Project Management Group  
Facilities Services

ADDENDUM #2  
January 19<sup>th</sup>, 2012

Project: Molecular Biology Renovation

**DRAWING NO.:**  
**A103**

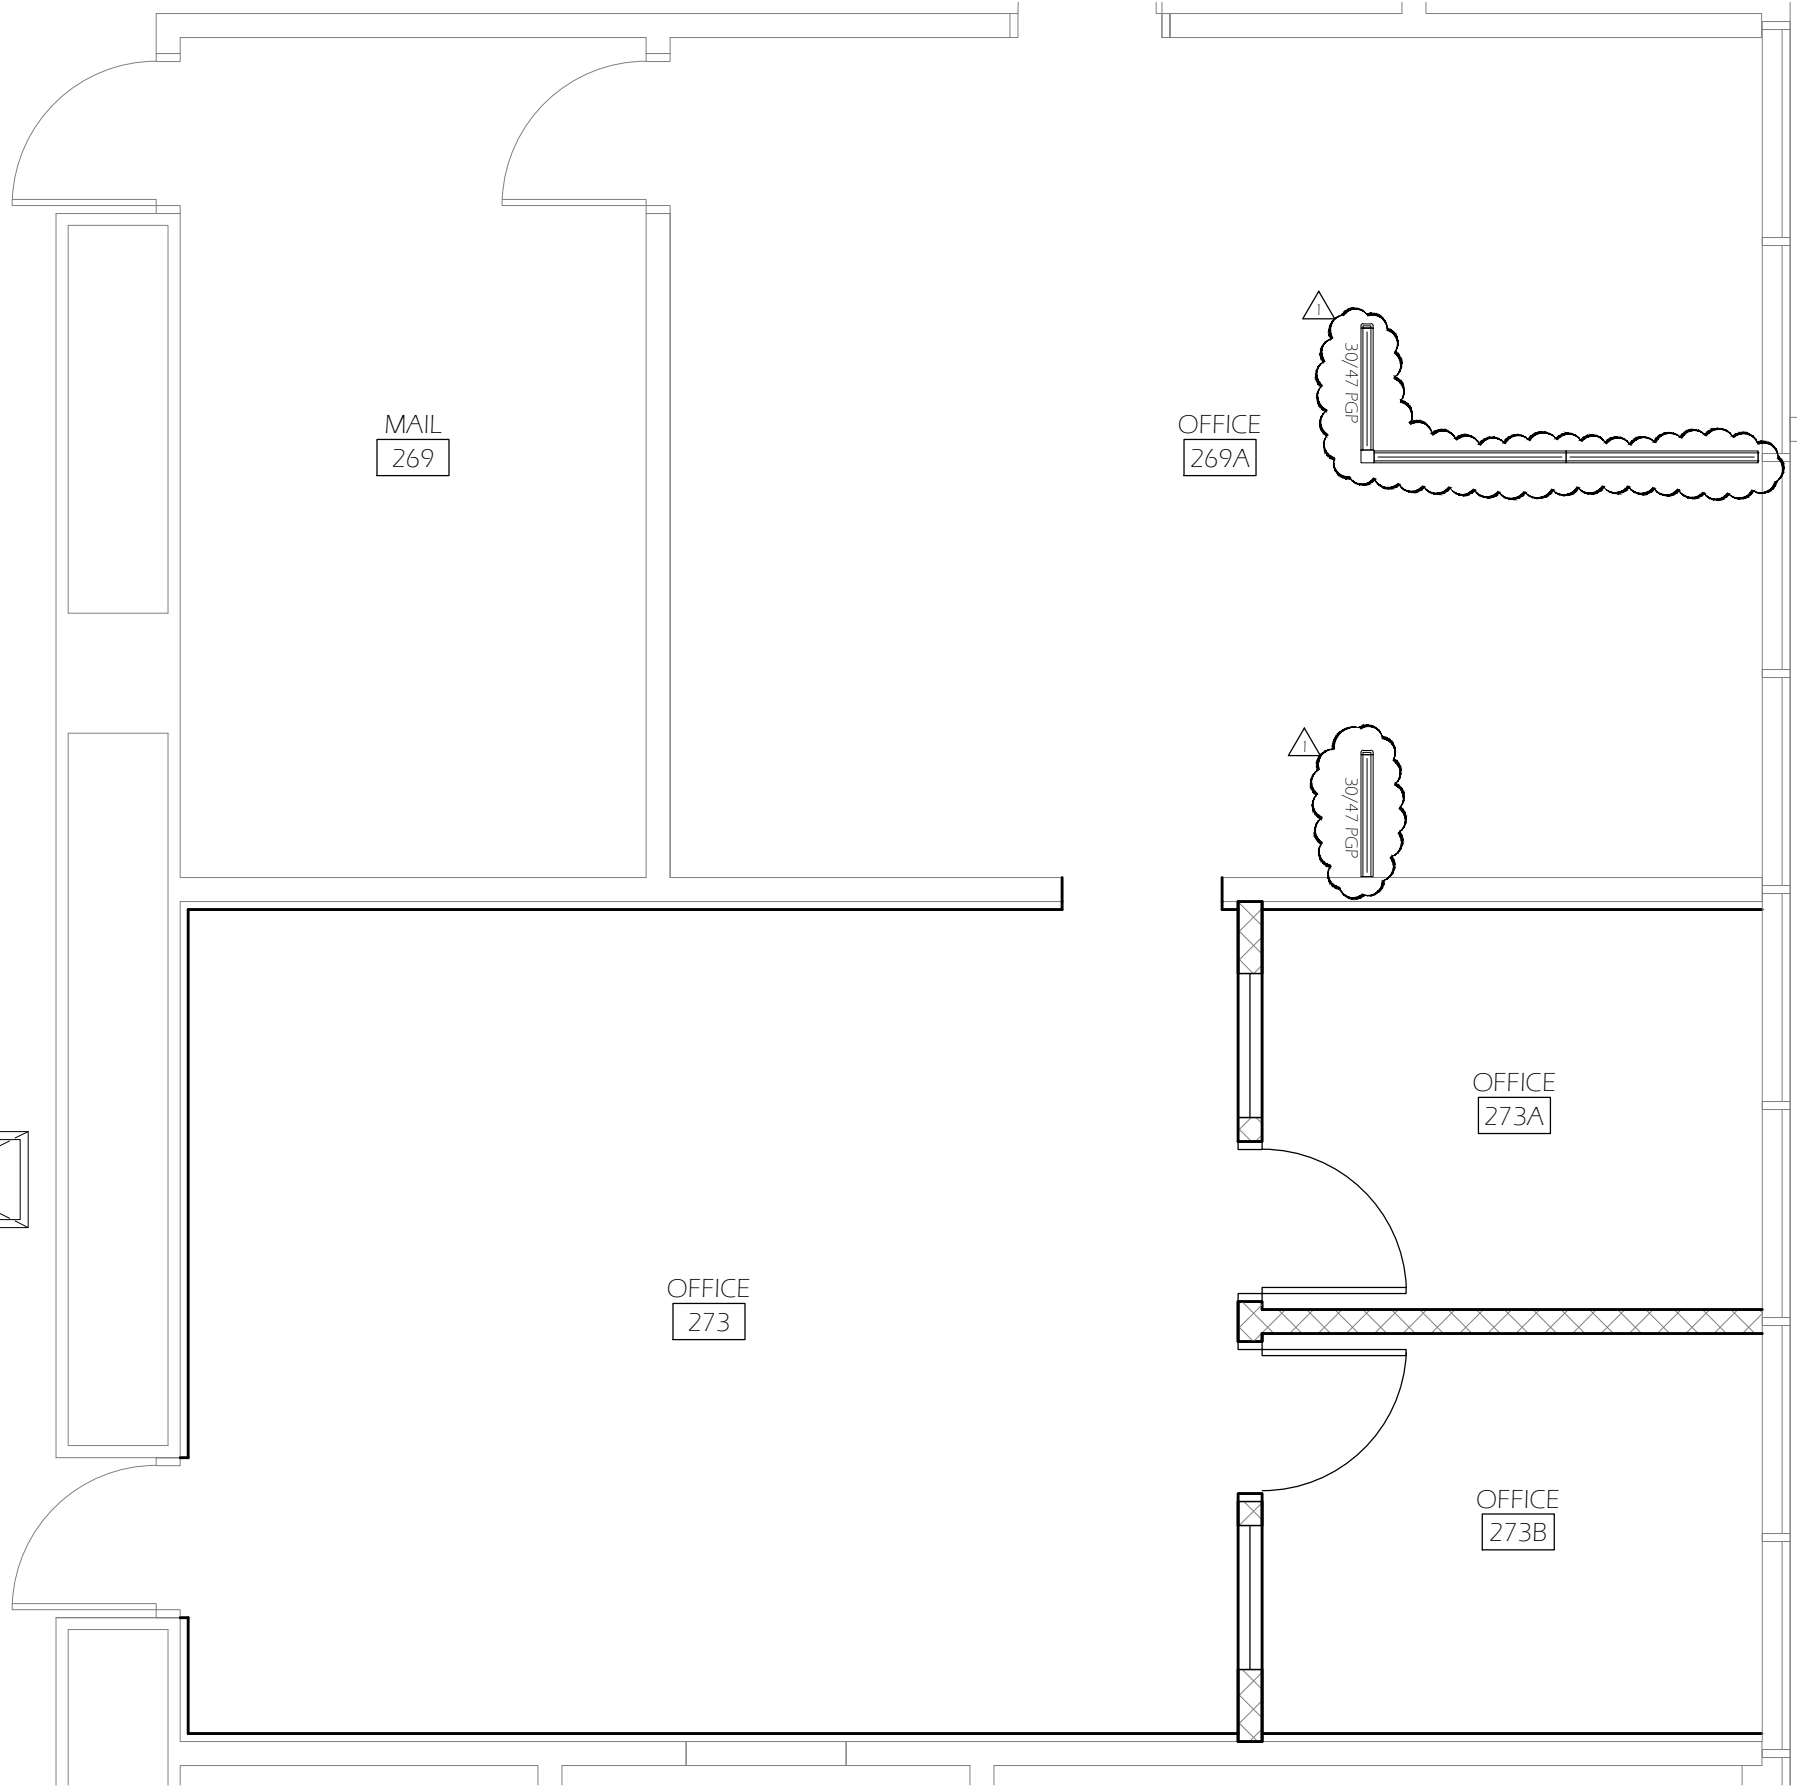
PGP panels in office 269A have been lowered. Revised drawing enclosed. Contact Office World for revised quote

Install blocking for Herman Miller Partitions as part of Base Bid

1. BASE BID WORK TO INCLUDE CFCI PARTITIONS AS NOTED. SECURE PARTITIONS TO WALL, NO ELECTRICAL OR DATA SERVICE TO BE INCORPORATED INTO PANELS. REFERENCE OFFICE WORLD PRICE QUOTE 10387, DATED 12/05/2011. REVISED 01/19/2012. CONTACT 541-687-9704

**DRAWING NO.:**  
**A104**

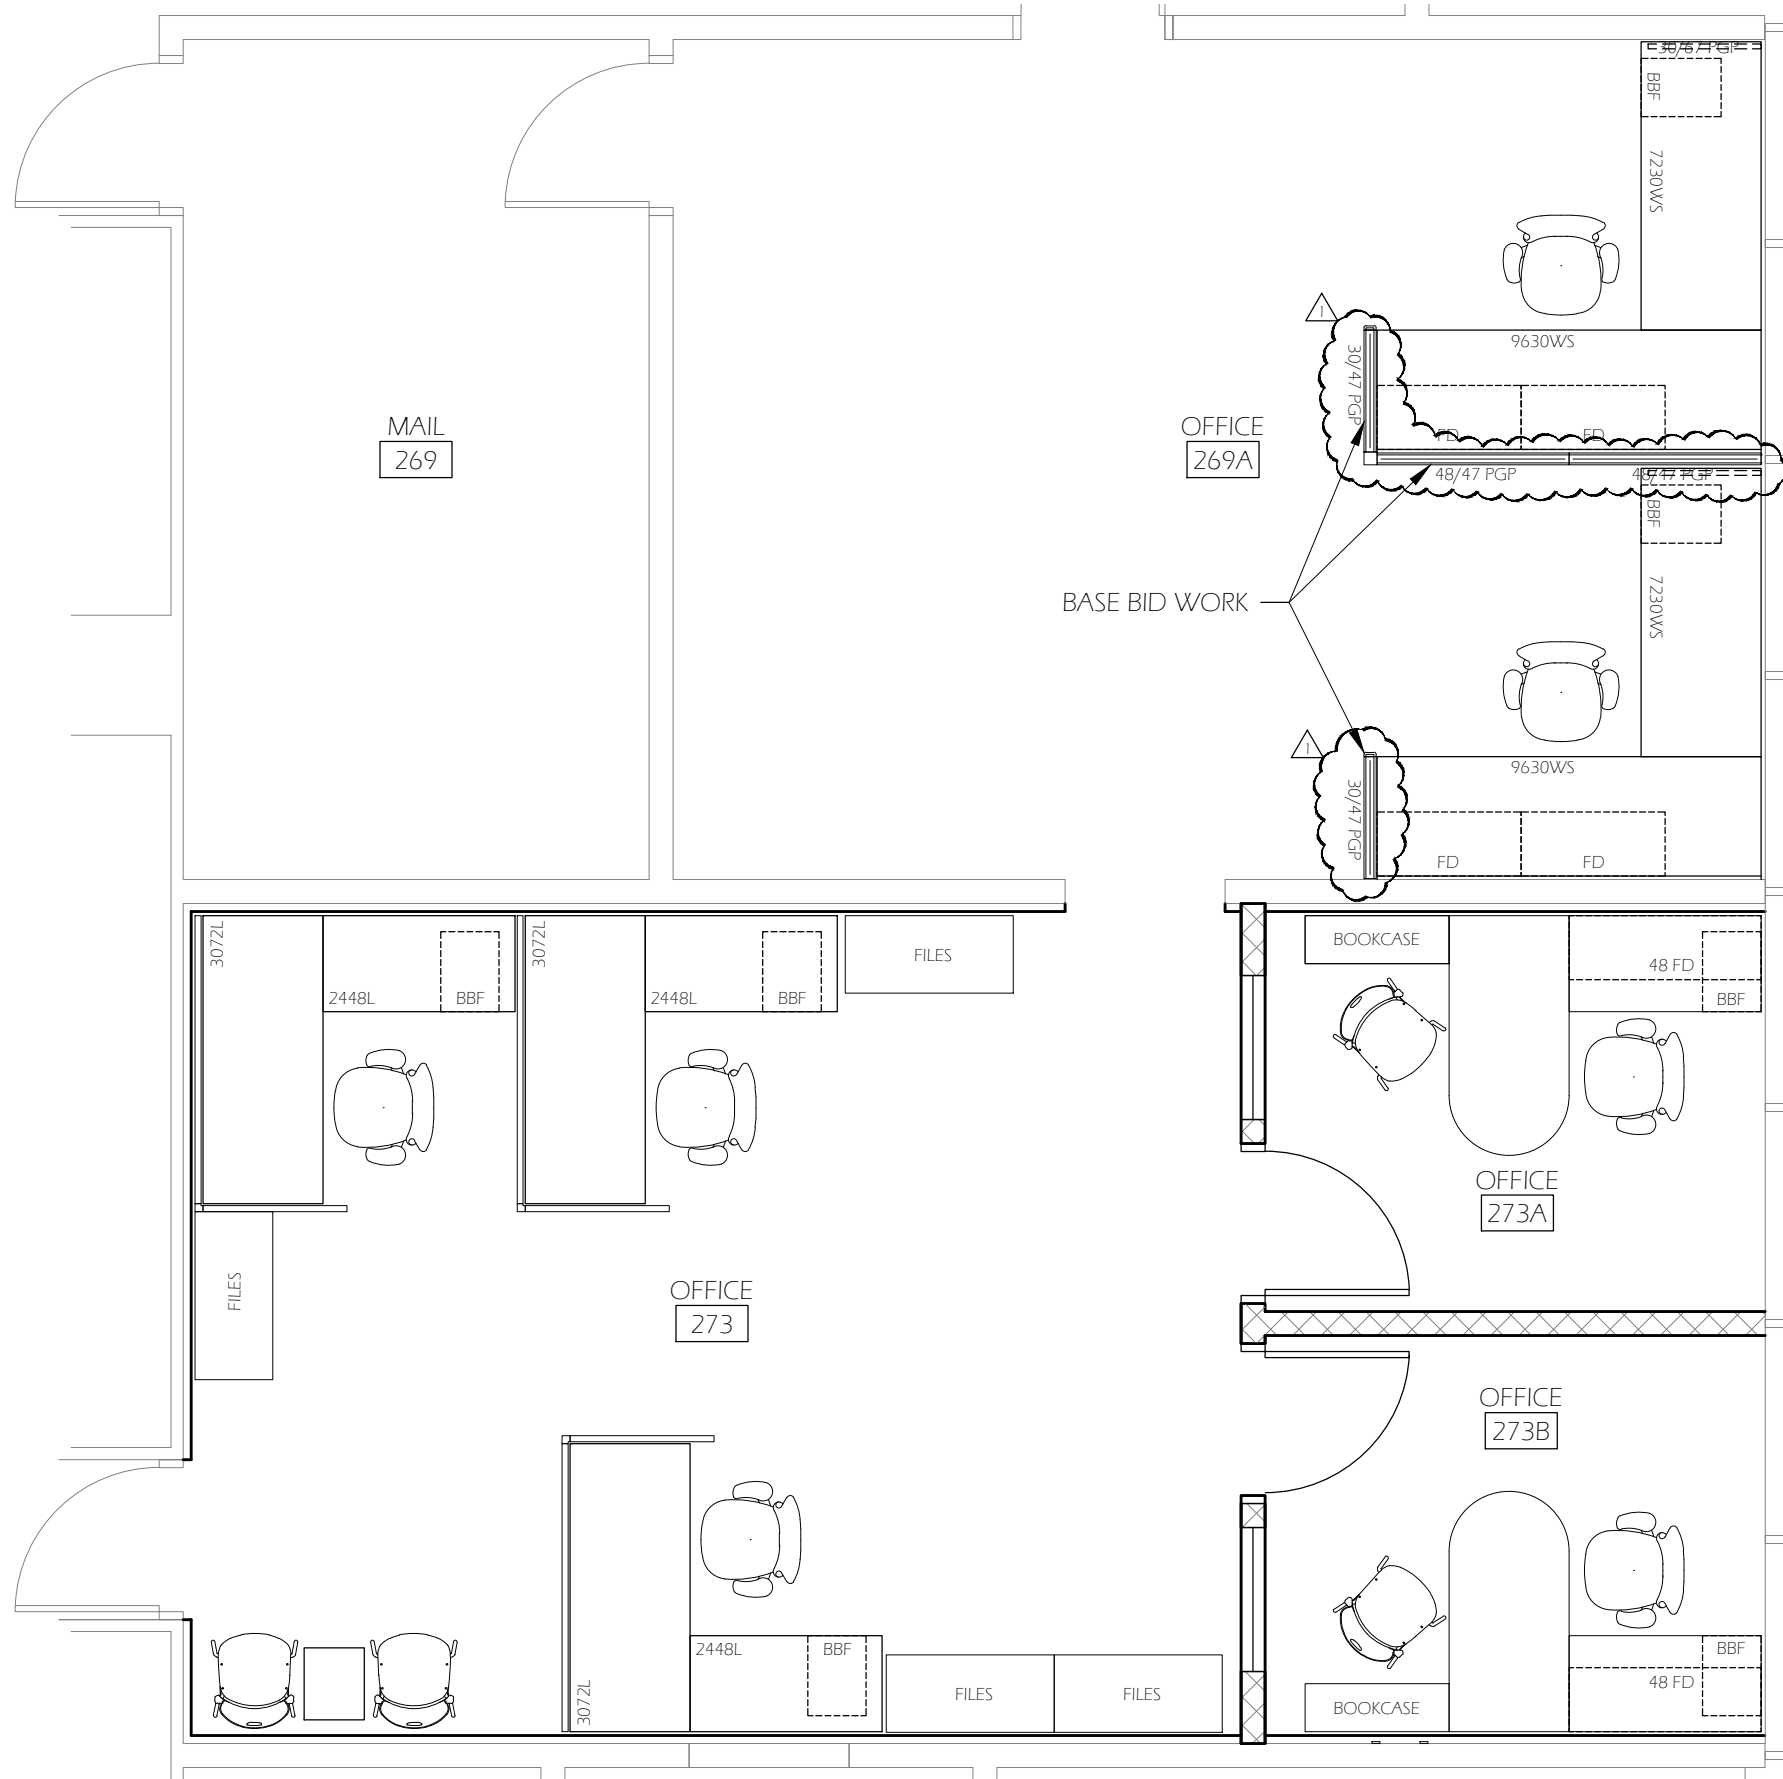
PGP panels in office 269A have been lowered. Revised drawing enclosed. Contact Office World for revised quote

Install blocking for Herman Miller Partitions as part of Base Bid

1. NOTE PANELS IN ROOM 269A ARE PART OF BASE BID WORK. REMAINDER OF FURNITURE TO BE ALTERNATE 1; REFERENCE OFFICE WORLD PRICE QUOTE 10387, DATED 12/05/2011. REVISED 01/19/2012. CONTACT 541-687-9704
